Addendum 05

PROJECT: Fort Loramie Local Schools Athletic Complex Building & Associated Improvements
600 East Park Street
Fort Loramie, Ohio 45845

PROJECT #: 25041.00

This addendum form is a part of the Contract Documents and modifies the Bidding Documents dated December 11, 2025 with amendments and additions noted below.

1 TC1.1 **FIRST FLOOR TECHNOLOGY CABLING PLAN - UNIT A**
1/8" = 1'-0"

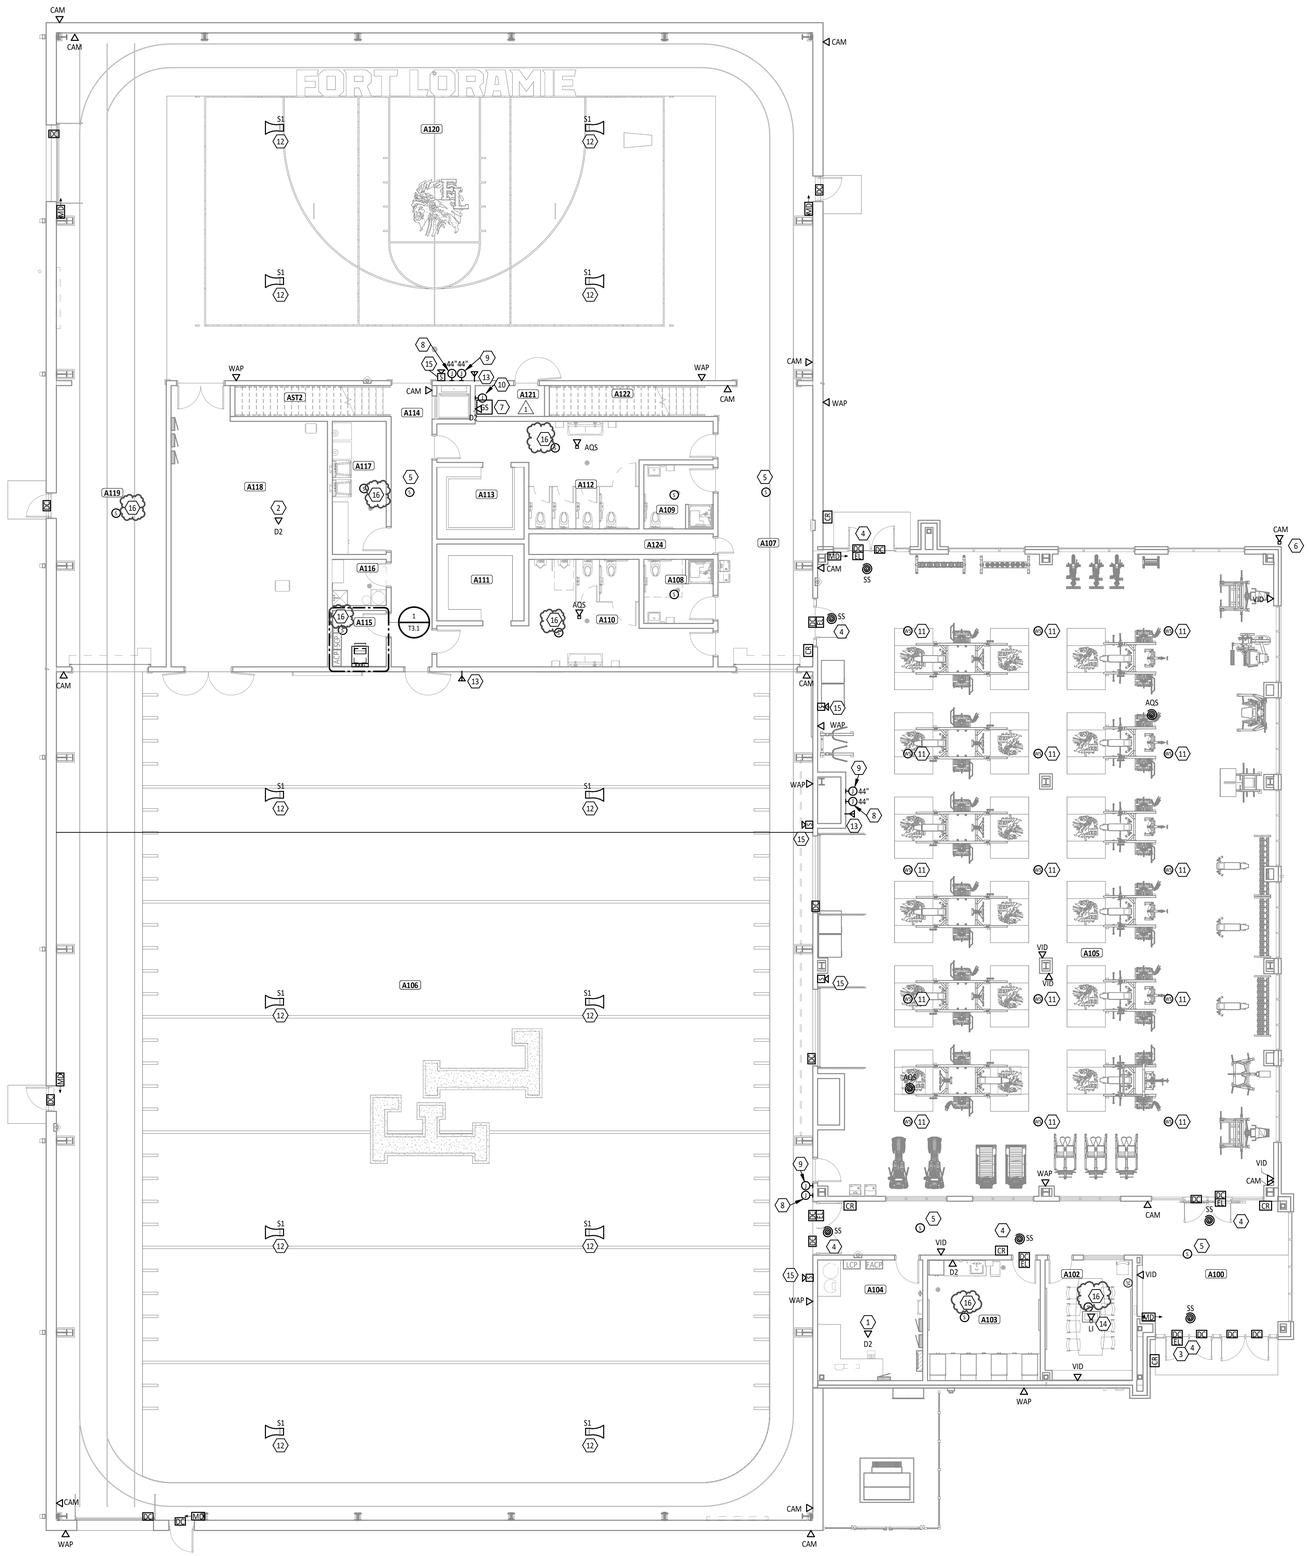
20. Sheet T1.3 – Technology Details
    a. Changed cable type from Cat6 to Cat6a
21. Sheet TC1.1 – First Floor Technology Cabling Plan
    a. Additional keynote to clarify speaker types

15. In the Athletic Complex, the floor plan shows ceiling speakers marked as "S." Could you please provide details or specifications for these speakers so we can understand what is required?
    a. **Response: Speaker specification keynotes have been added to TC1.1 updated in Addendum 05**
